Product Change Notice (PCN)

PCN Number: PCN-0451201R-02

Product(s) Affected: *PJ-056*

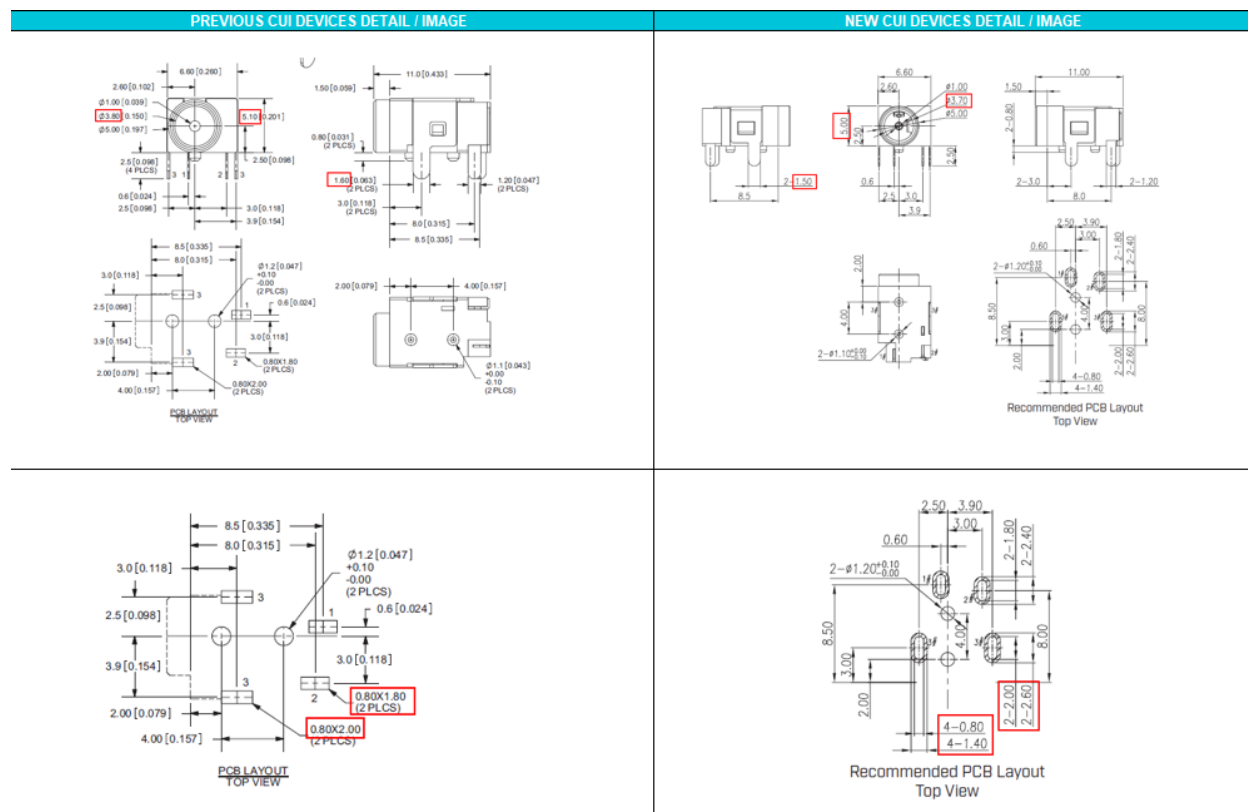
Description of Change: *Minor Housing and Material Difference. See image Below*

PREVIOUS CUI DEVICES DETAIL / IMAGE			NEW CUI DEVICES DETAIL / IMAGE		
	MATERIAL	PLATING			
center pin	brass	tin			
terminal 1	brass	tin	terminal 1	brass	tin
terminal 2	copper alloy	tin	terminal 2	copper alloy	tin
terminal 3	copper alloy	tin	terminal 3	copper alloy	tin
plastic	PA66		housing	PBT (UL94V-0)	black
